Title - Sujet RCMP 'F' Div HQ Office Renovation	
Solicitation No. - N° de l'invitation EV385-130875/A	Amendment No. - N° modif. 001
Client Reference No. - N° de référence du client EV385-130875	Date 2012-07-17
GETS Reference No. - N° de référence de SEAG PW-\$PWW-199-4508	
File No. - N° de dossier PWW-2-35049 (199)	CCC No./N° CCC - FMS No./N° VME
Solicitation Closes - L'invitation prend fin at - à 02:00 PM on - le 2012-08-02	
Time Zone Fuseau horaire Central Standard Time CST	
F.O.B. - F.A.B. Plant-Usine: <input type="checkbox"/> Destination: <input checked="" type="checkbox"/> Other-Autre: <input type="checkbox"/>	
Address Enquiries to: - Adresser toutes questions à: Okemaysim, Tammy L.	Buyer Id - Id de l'acheteur pww199
Telephone No. - N° de téléphone (306) 975-6583 ()	FAX No. - N° de FAX (306) 975-5397
Destination - of Goods, Services, and Construction: Destination - des biens, services et construction: RCMP F Division Headquarters 6101 Dewdney Avenue Regina, Saskatchewan S4P 3K7

1. ADDENDUM N° 1

Se reporter à l'Addendum n° 1 – Rénovations des bureaux du quartier général de la division F de la GRC, Regina (Saskatchewan)

The following information supplements and/or supersedes

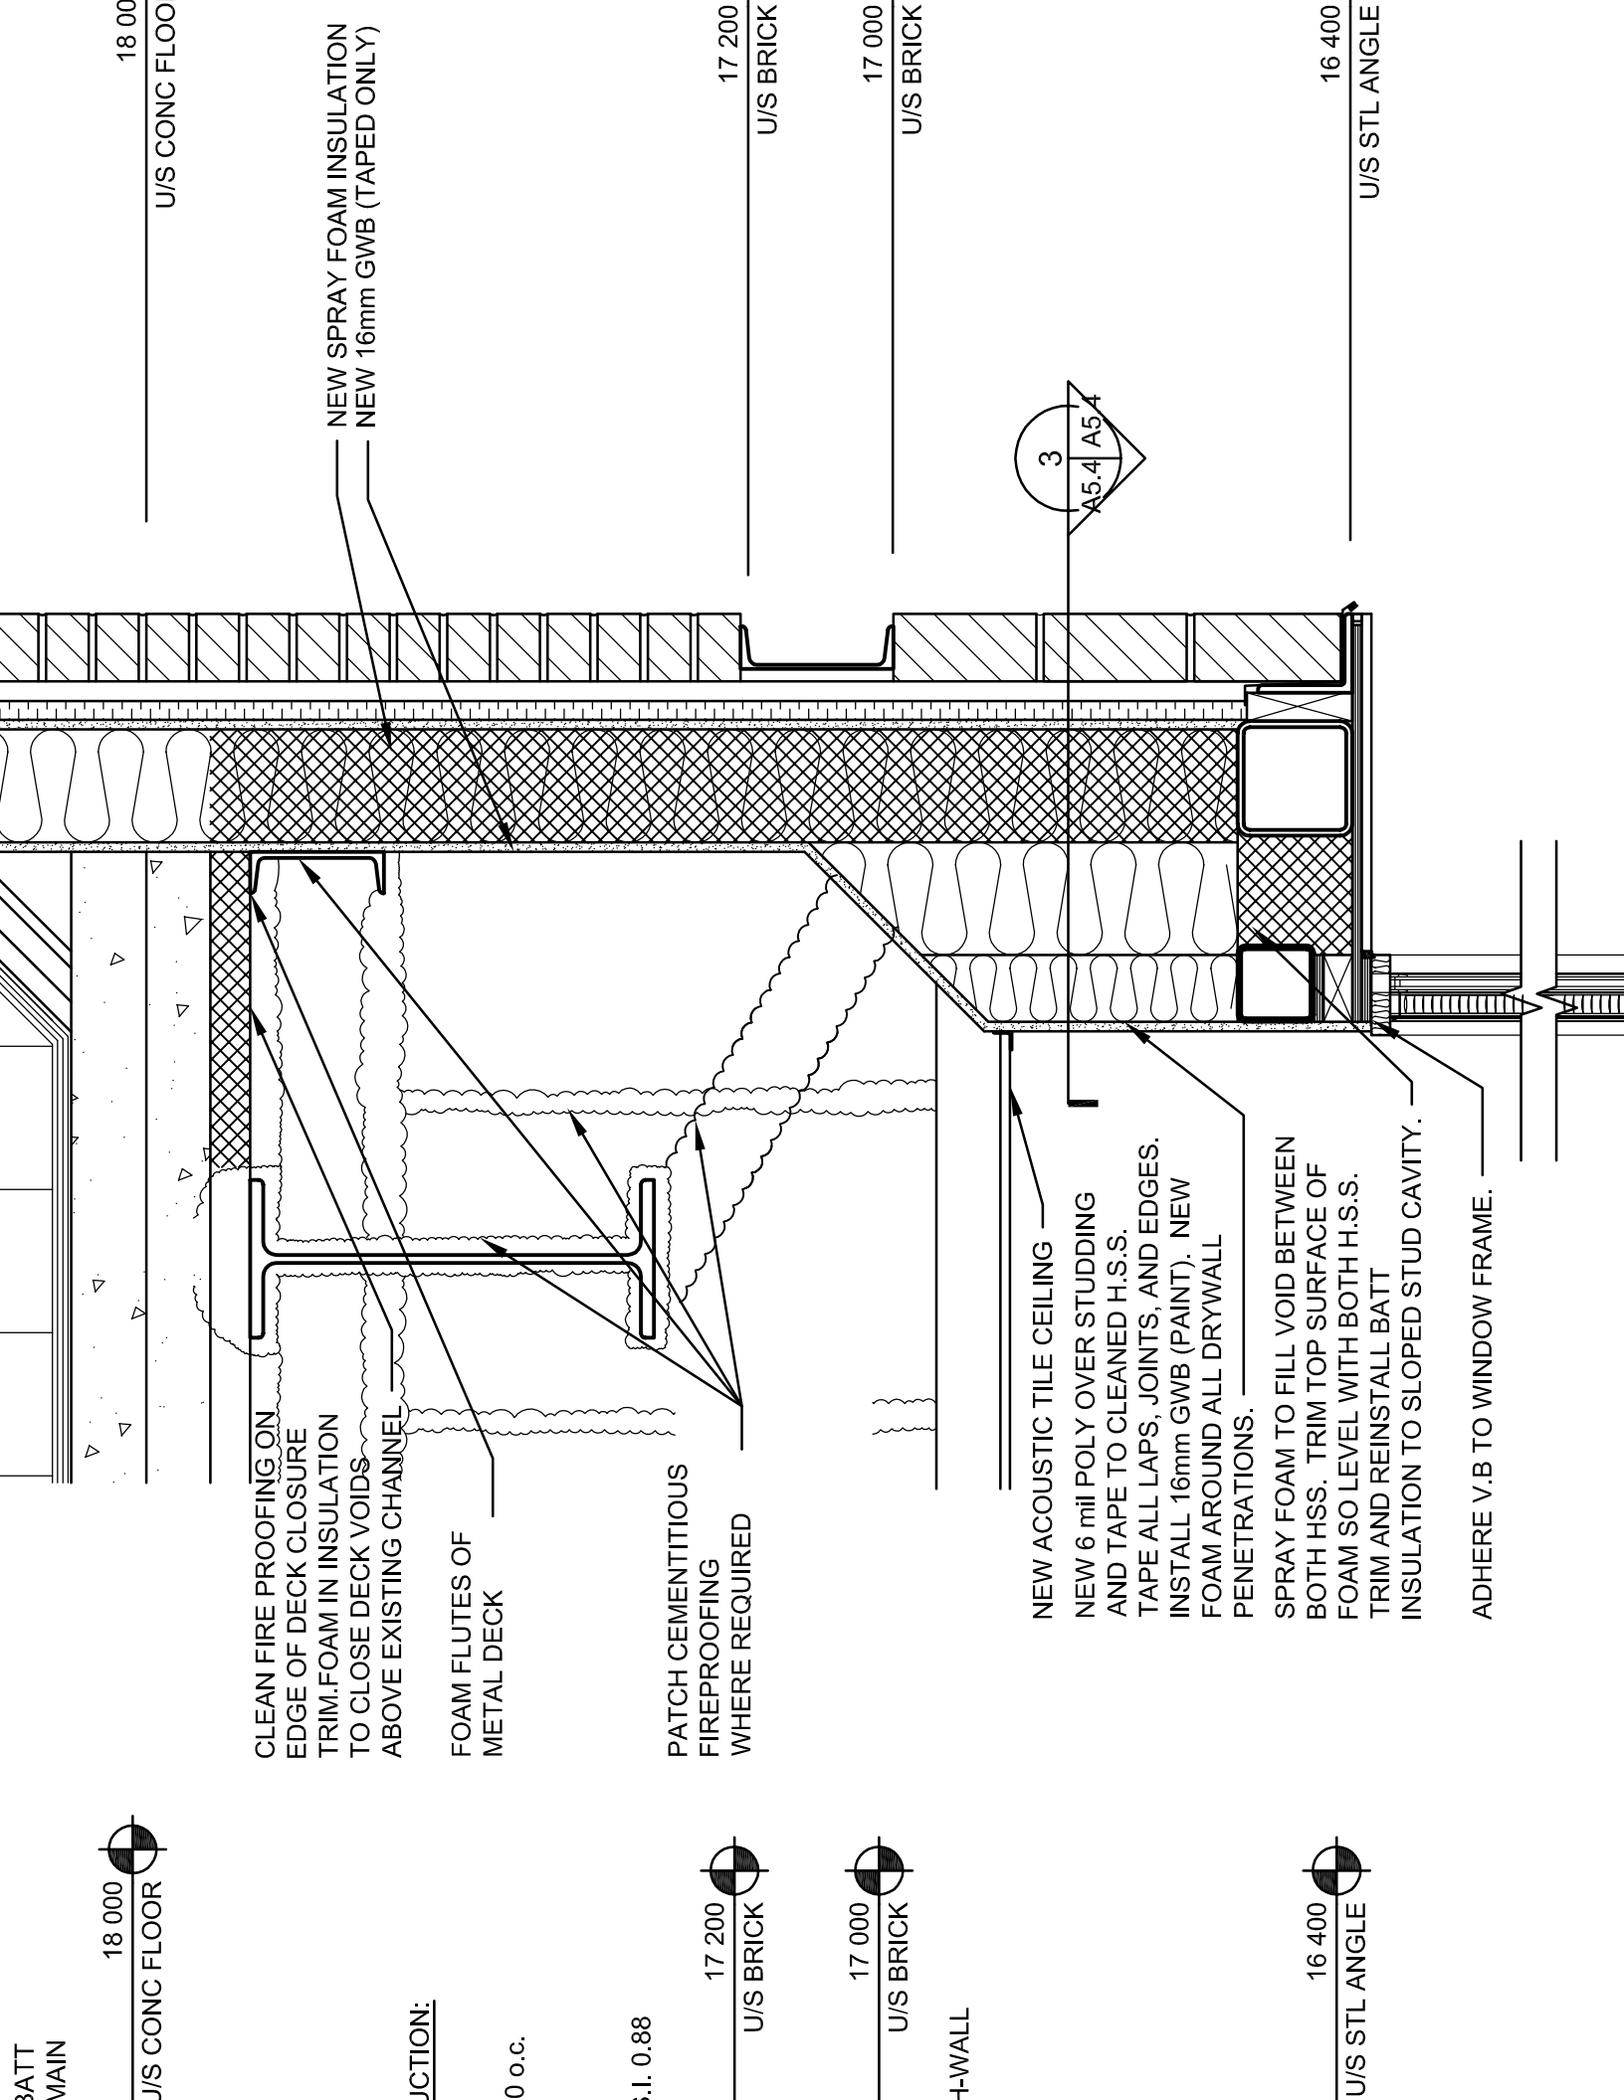
1.5	<u>Drawing A1.2 – Construction Plans and Details</u> Delete A1.2 in its entirety. Replace with Drawing A1.2R dated July 6, 2012
1.6	<u>Drawing A2.1 Room 113.02 Plans and Details</u> Detail 2 – Reflected Ceiling Plan: Contractor shall apply a spray-on fireproofing to the existing steel deck ceiling to provide the required 3 Hour fire rating of the ceiling assembly.
